Access Compliance Report

Public Rights-of-Way

Intersection ID: 11882	Main Street: N_PINE_ST	Cross Street: W_5TH_ST	Location: S
ADA ID: 7336A06B4588	Ramp Type: Perp	Initial Pass/Fail: Fail	Overall Compliance: No
		Severity Score: 12.5

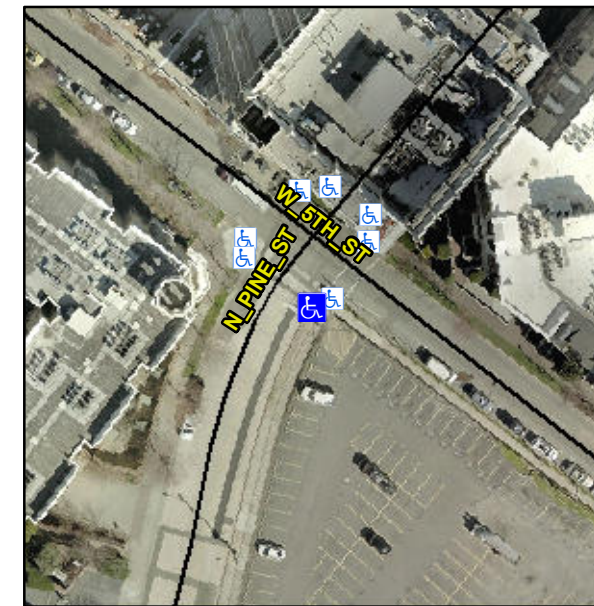
Not Found, R304.2.2

Compliance	Description	Data	Compliance	Description	Data
N/A	Ramp Length (in)	63.0	No	Ramp Slope (%)	9.0
Yes	Ramp Width (in)	51.0	Yes	Ramp XSlope (%)	0.5
N/A	Flare Type LT	N/A	N/A	Flare Type RT	N/A
N/A	Flare Slope LT (%)	N/A	N/A	Flare Slope RT (%)	N/A
N/A	Flare Traversable LT?	N/A	N/A	Flare Traversable RT?	N/A
N/A	Landing Length (in)	N/A	N/A	DWS Provided?	N/A
N/A	Landing Width (in)	N/A	N/A	DWS Contrast?	N/A
N/A	Landing Slope (%)	N/A	N/A	DWS Length (in)	N/A
N/A	Landing X Slope (%)	N/A	N/A	DWS Full Width?	N/A
N/A	Landing Curb? (Y/N)	N/A	N/A	DWS Offset (in)	N/A
N/A	Shared Landing?	N/A			
N/A	Gutter Ponding?	N/A	N/A	Gutter Slope (%)	N/A
N/A	Gutter Lip Ht (in)	N/A	N/A	Gutter X Slope (%)	N/A
N/A	Painted X Walk1?	Yes	N/A	Painted X Walk2?	N/A
	X Walk 1 Direction	To NW		X Walk 2 Direction	N/A
N/A	X Walk 1 Width (in)	99.0	N/A	X Walk 2 Width (in)	N/A
	X Walk 1 Slope (%)	0.1		X Walk 2 Slope (%)	N/A
	X Walk 1 X Slope (%)	2.7		X Walk 2 X Slope (%)	N/A

Remove & Replace Entire Ramp.
